**TMS320F28055, TMS320F28054,
TMS320F28053, TMS320F28052,
TMS320F28051, TMS320F28050 Piccolo MCU**

Silicon Errata

Literature Number: SPRZ362A
November 2012–Revised April 2013

Figure 1. Example of Device Markings

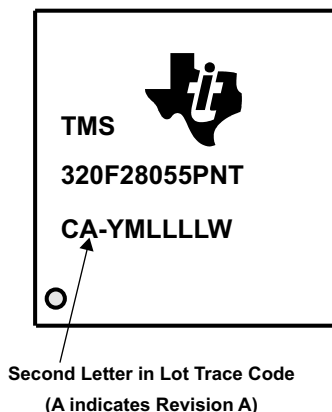
LOCATION	ADDITIONS, DELETIONS, AND MODIFICATIONS
Figure 1	Example of Device Markings: Updated figure to show silicon revision A example markings
Table 1	Determining Silicon Revision From Lot Trace Code: - Added silicon revision A data - Added footnote about Boot-ROM contents
Figure 2	Example of Device Nomenclature: Updated figure to show "TMS" example
Section 4	Known Design Marginality and Exceptions to Functional Specifications: Updated Workaround in "Zero-Pin Oscillator: Modification to Oscillator Frequency Parameter" advisory
